To: Kristopher Byrd, Well Construction Manager
From: Tommy Laird, Well Construction Program Coordinator
Subject: Review of Water Right Application G-19038
Date: October 30, 2023

Application # G- 19038

TO: Water Rights Section Date 2/13/2023
 FROM: Groundwater Section Stacey Garrison/Travis Brown
 Reviewer's Name
 SUBJECT: Application G- 19038 Supersedes review of 1/18/2022
 Date of Review(s)

D1. Well #: 1 Logid: CLAC 69616

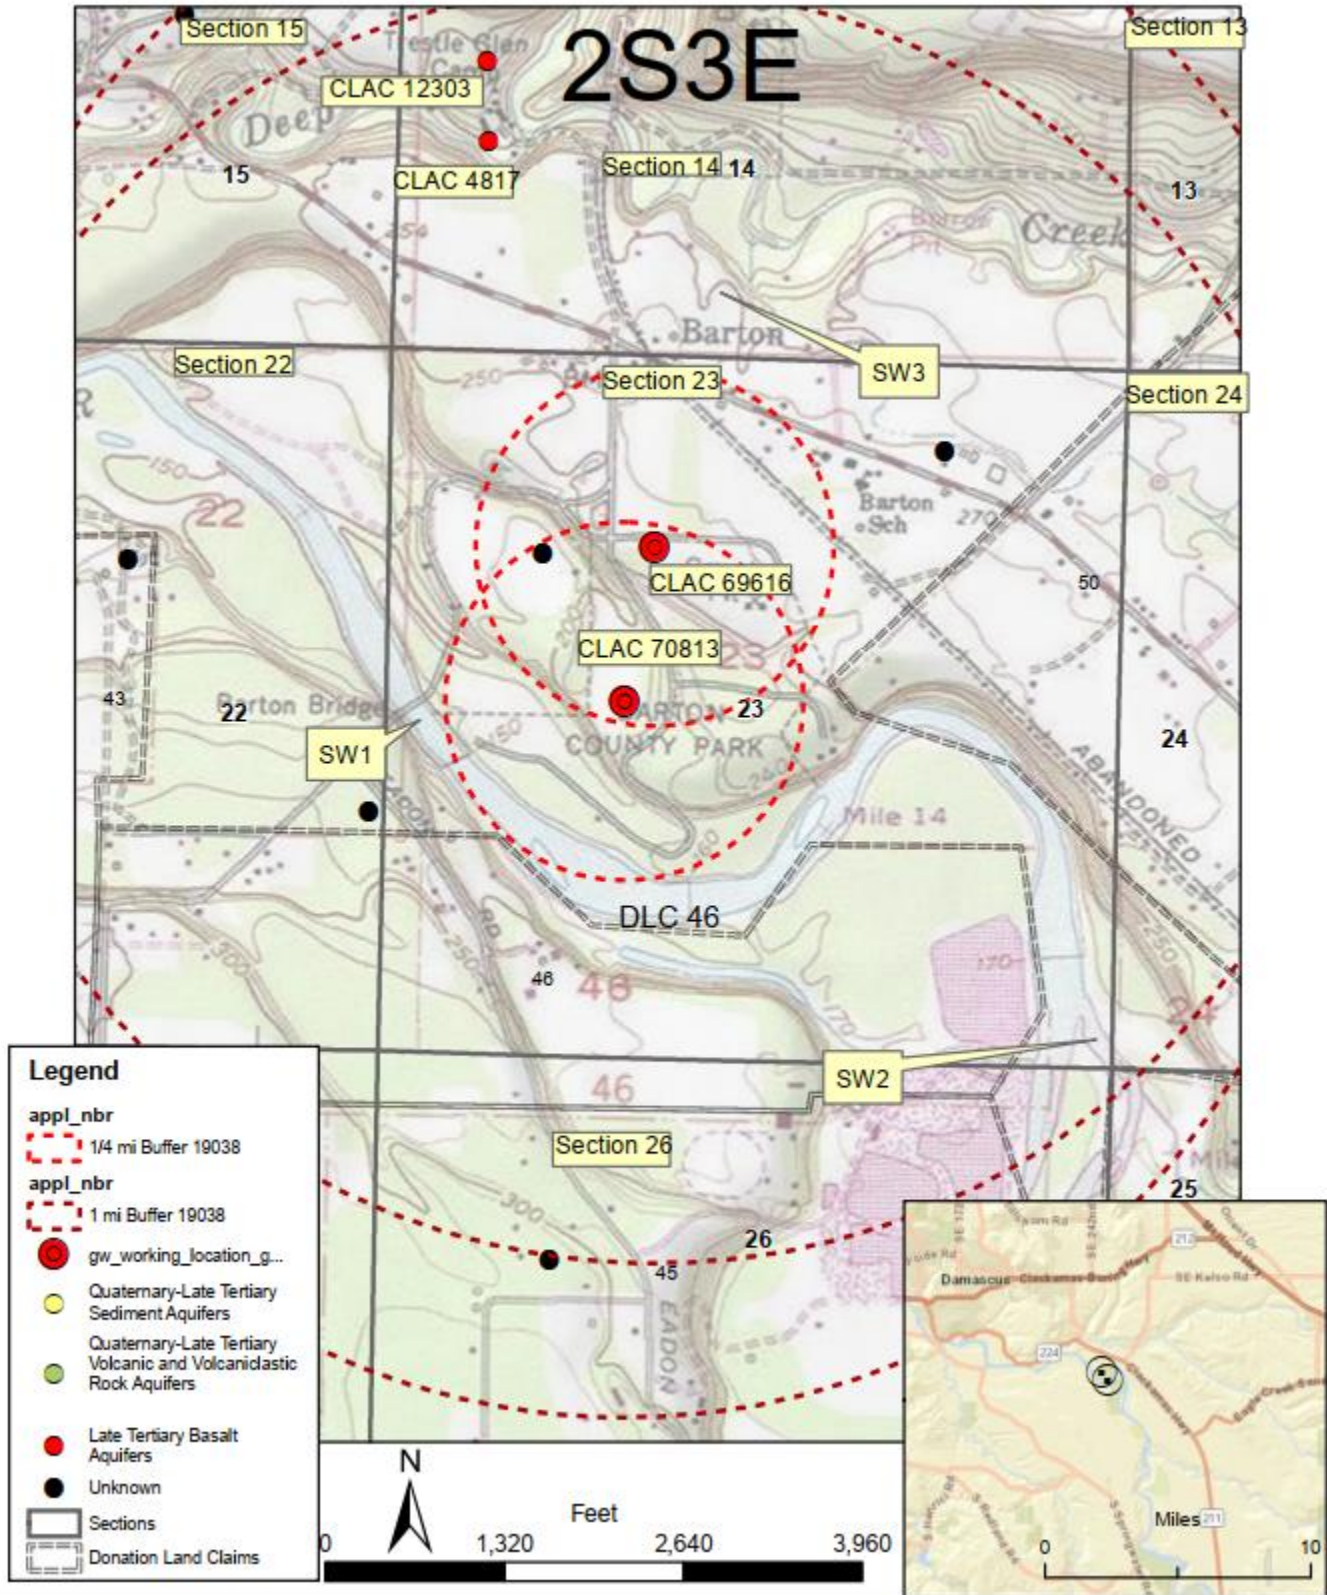
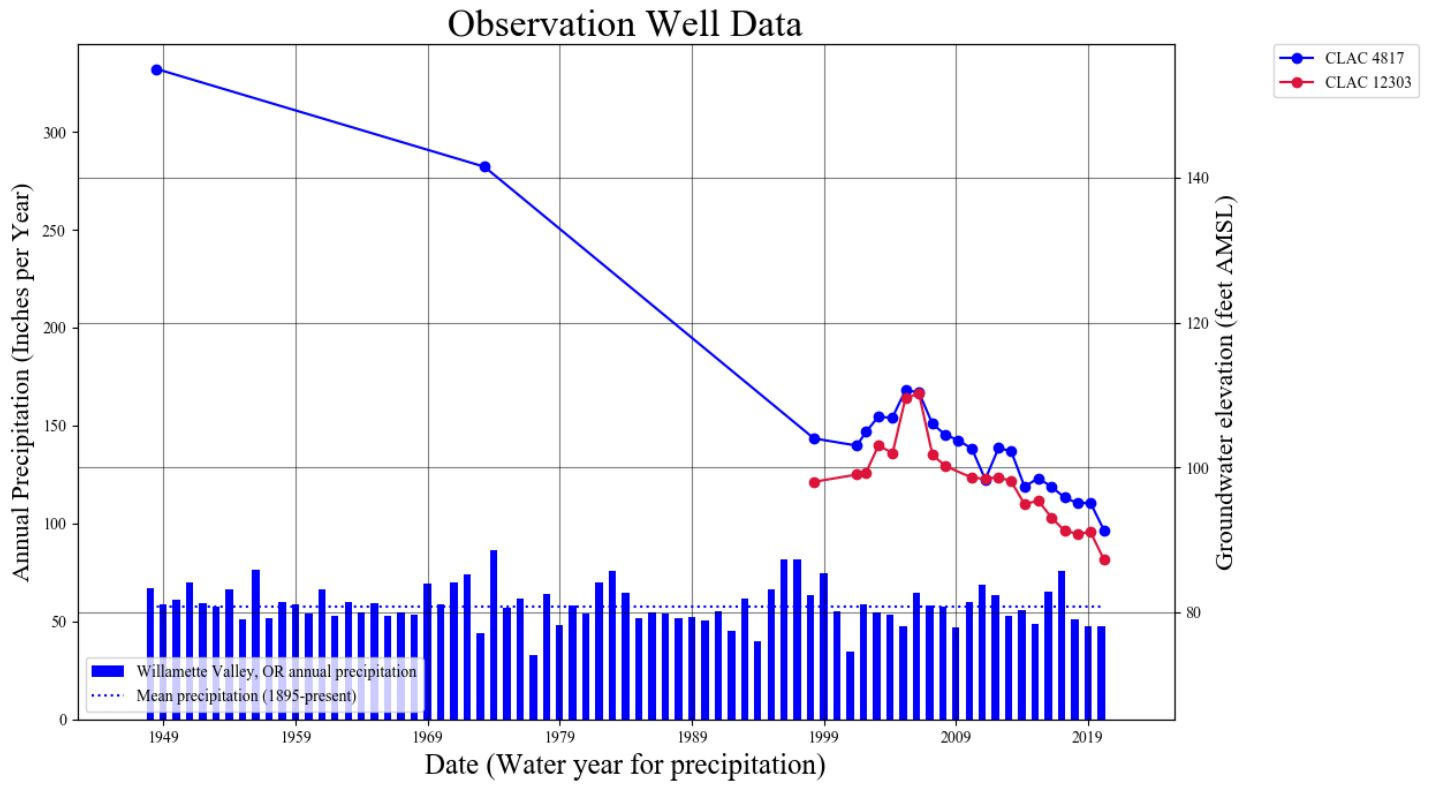
D2. **THE WELL does not appear to meet current well construction standards based upon:**

D3. **THE WELL construction deficiency or other comment is described as follows:** Well 1 (CLAC 69616) appears to have been completed with a split seal but the lower, under-reamed drillhole does not extend at least fifteen feet into solid, unfractured, consolidated rock overlying the water-bearing rock formation per OAR 690-210-0150(1)(c) Method 3. The under-reamed (8" diameter) portion of CLAC 69616 is only 10, from 707 to 717 ft bls.

D4. **Route to the Well Construction and Compliance Section for a review of existing well construction.**
